**Prairie Island Nuclear Generating Plant**

**Response to Request for Additional Information Regarding  
Report NSPLMI-96001, Individual Plant Examination of External Events (IPEEE),  
Related to Generic Letter 88-20**

## **Response to RAI Seismic Questions**

Figure 1. Success Block Diagram

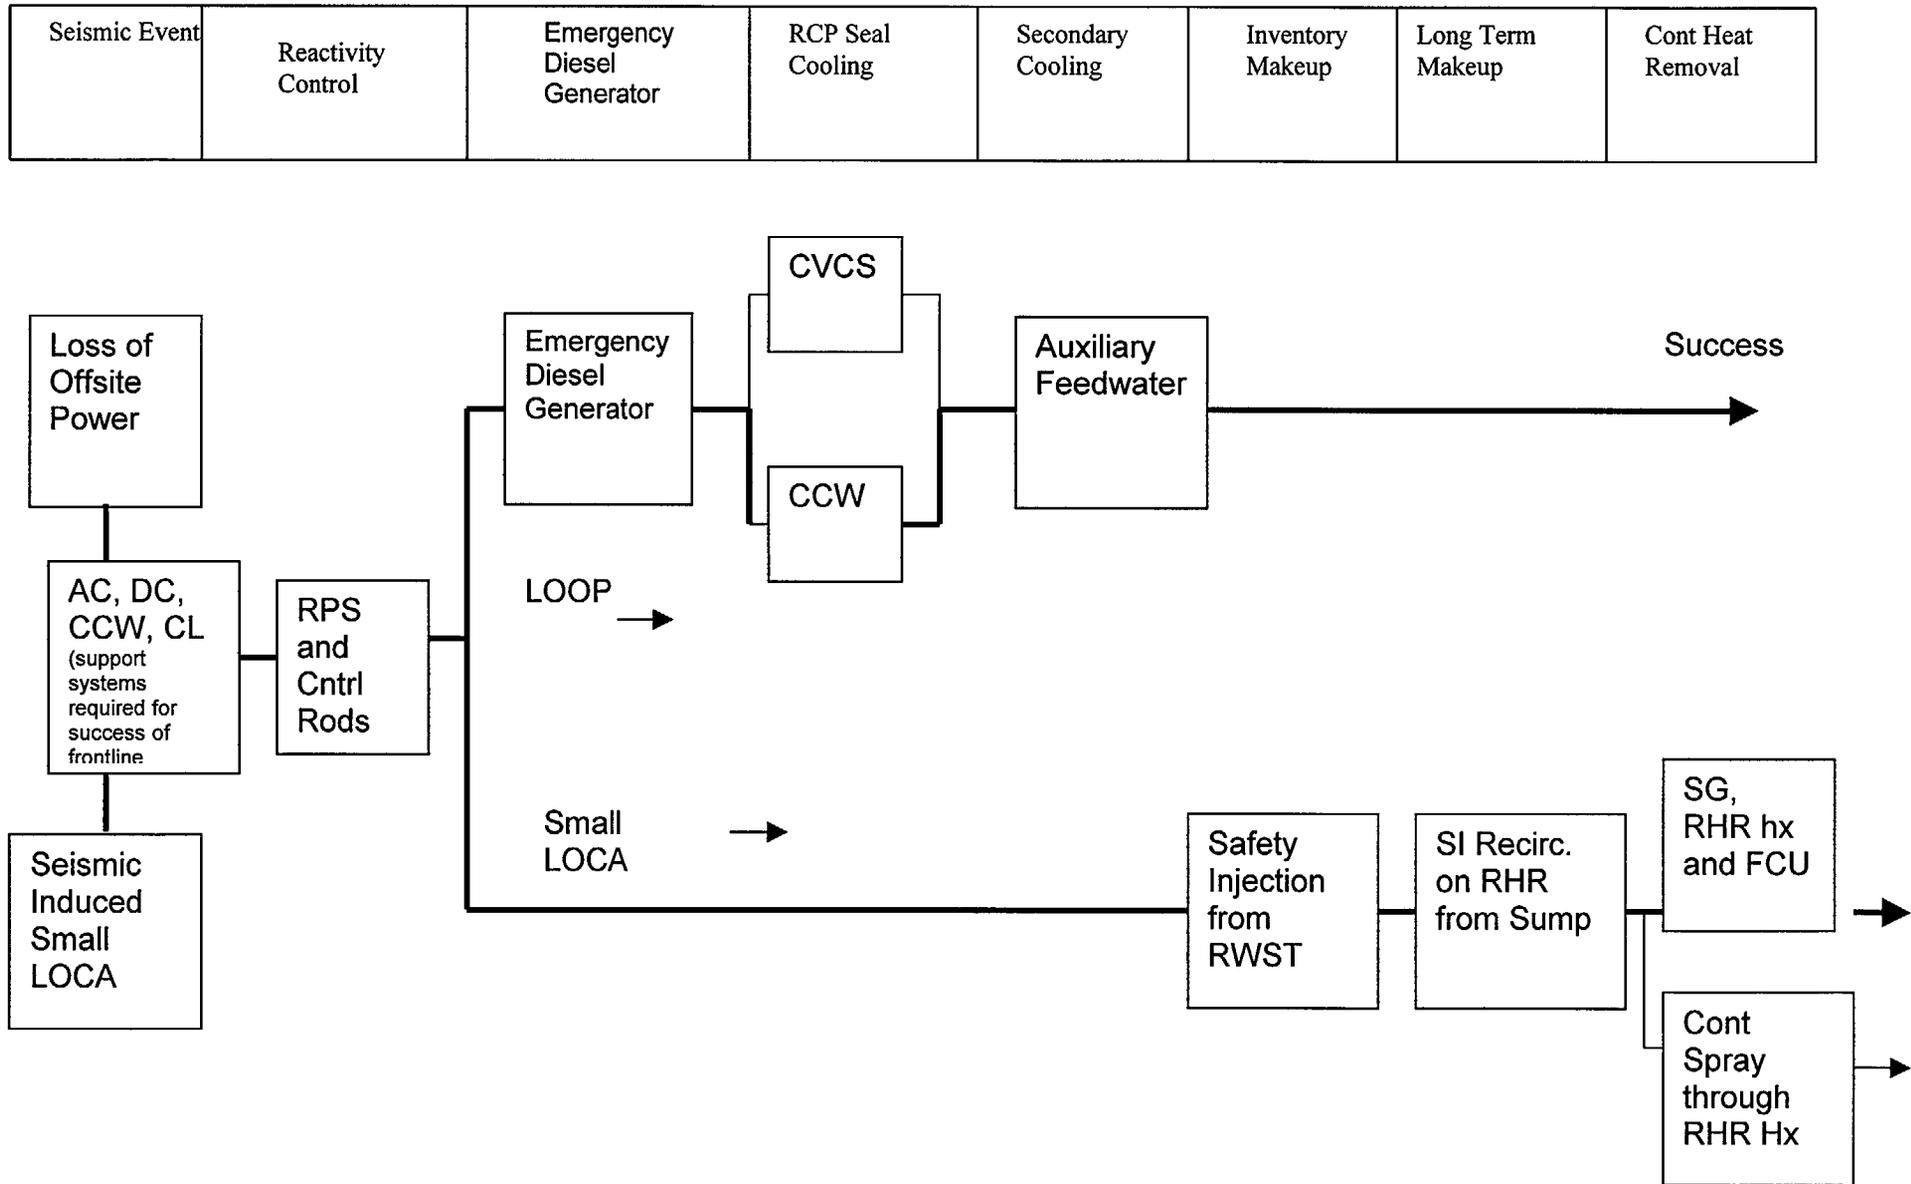
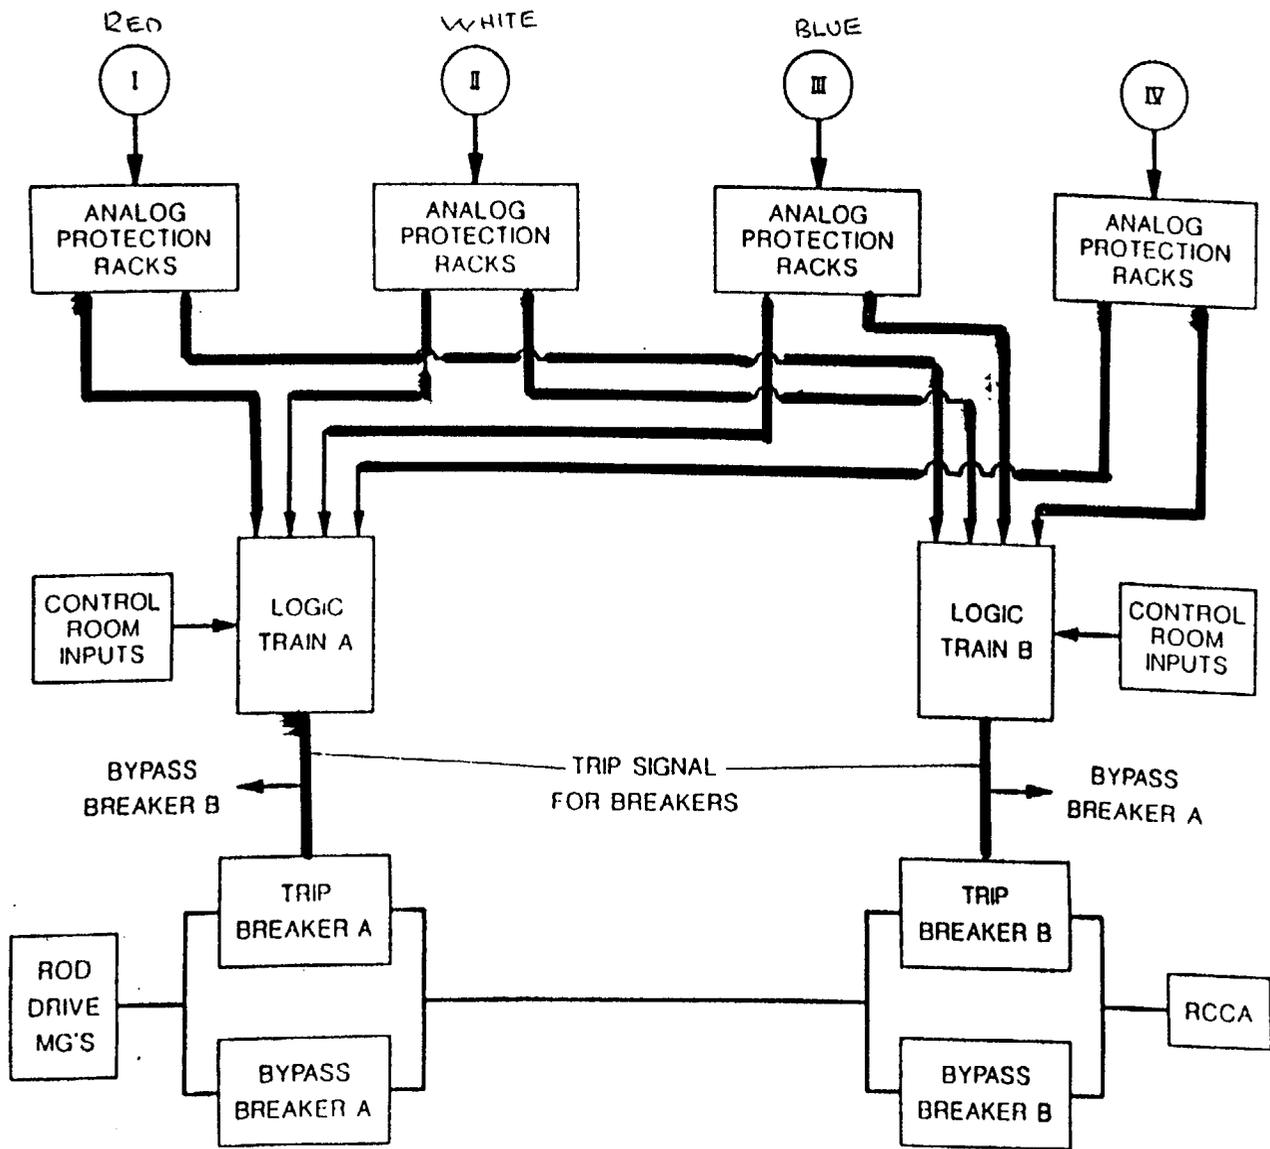
success path selection of structures, systems, and components are not consistent with those described in EPRI NP-6041-SL. Success path logic diagrams (SPLDs) were not provided in the IPEEE submittal; although equipment for important safety functions were identified and discussed, specific success paths that could bring the plant to a safe shutdown condition were not identified. It is not clear whether the selected equipment can provide two success paths with sufficient redundancy and diversity.

Please provide information on success path development and system selection consistent with that described in EPRI NP-6041-SL. Please include in the discussion the development and identification of the success paths, the systems and equipment included in the Safe Shutdown Equipment List (SSEL) and their safety functions, and the isolation of systems that are excluded from the SSEL (for example, successful isolation of the condensate storage tanks when the water source of the auxiliary feedwater (AFW) pumps is switched).

*The success path block diagrams for loss of offsite power and for a small LOCA are shown in Figure 1. Table 1 lists the CSFs credited and identifies the preferred and alternate systems supporting these CSFs. It also provides the figure numbers (Figures 2 through 13) for the attached simplified line diagram of each system. The trains of major equipment credited in the seismic margins assessment are highlighted in the line diagrams. The simplified flow diagrams developed for the Internal Events PRA serve as a substitute for success path block diagrams. The preferred systems have at least two independent trains, as shown in the system line diagrams.*

Figure 18

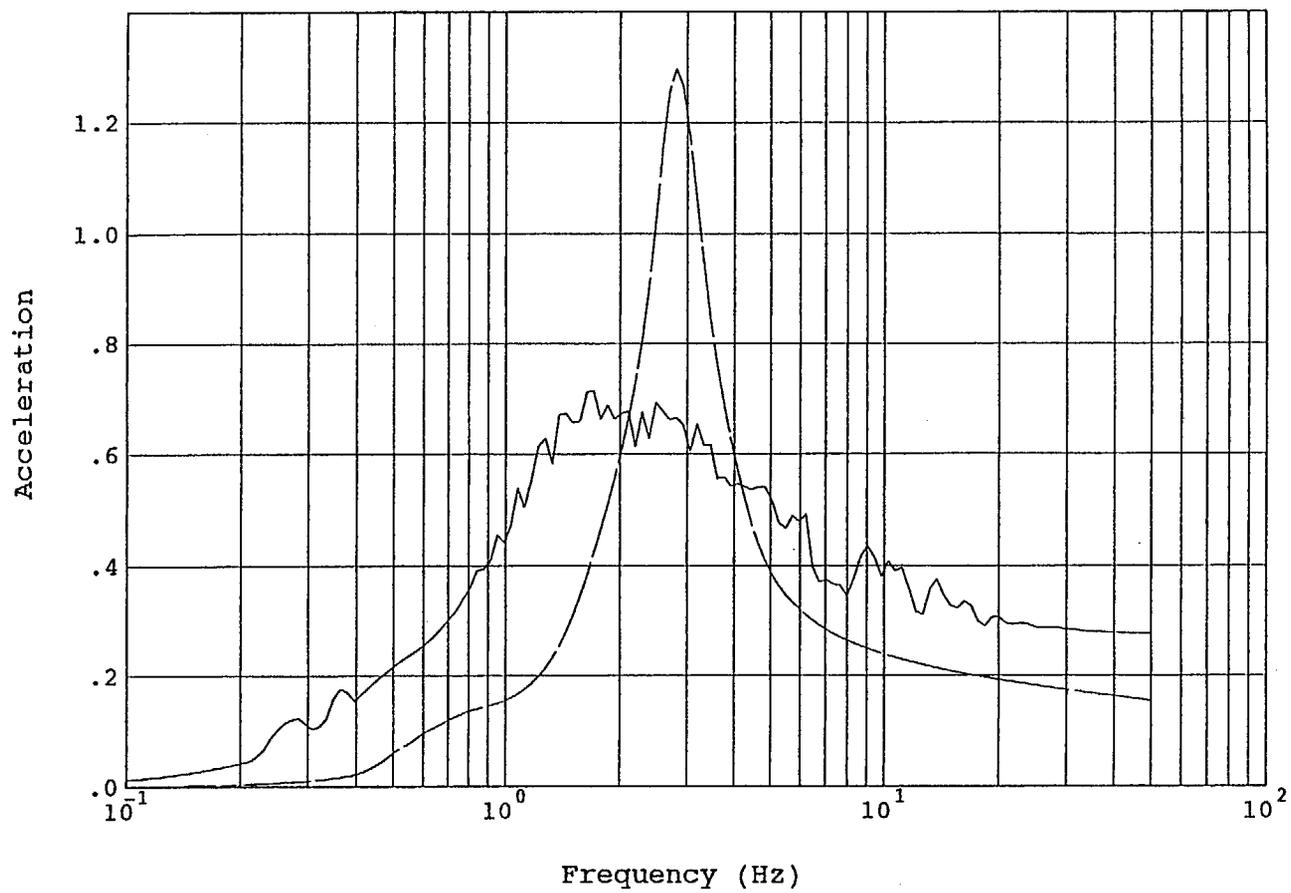
- 2/e) the comparisons of the design basis ground spectrum and in-structure response spectra (IRS) to the IPEEE 0.3g pga RLE ground spectrum and in-structure response spectra. If scaling is used, describe the scaling method. If new IRS are generated, describe the analyses performed to generate all significant RLE IRS.

Examination of the Reactor-Auxiliary-Turbine Building RLE IRS confirms that application of the free-field 0.3g RLE ground response spectra at and below grade of the Screenhouse is reasonable. As shown in Figures 18, 19, 22, 23, 28, and 29, the Reactor-Auxiliary-Turbine Building RLE IRS at Elevations 697.5' and 695', which correspond to the top of base mat, are less than the free-field 0.3g RLE ground response spectra at frequencies greater than about 3 Hz which typically corresponds to fundamental frequencies of components vulnerable to seismic effects. Exceedances of the free-field ground response spectra at frequencies between about 1.5 Hz and 3 Hz are minimal.
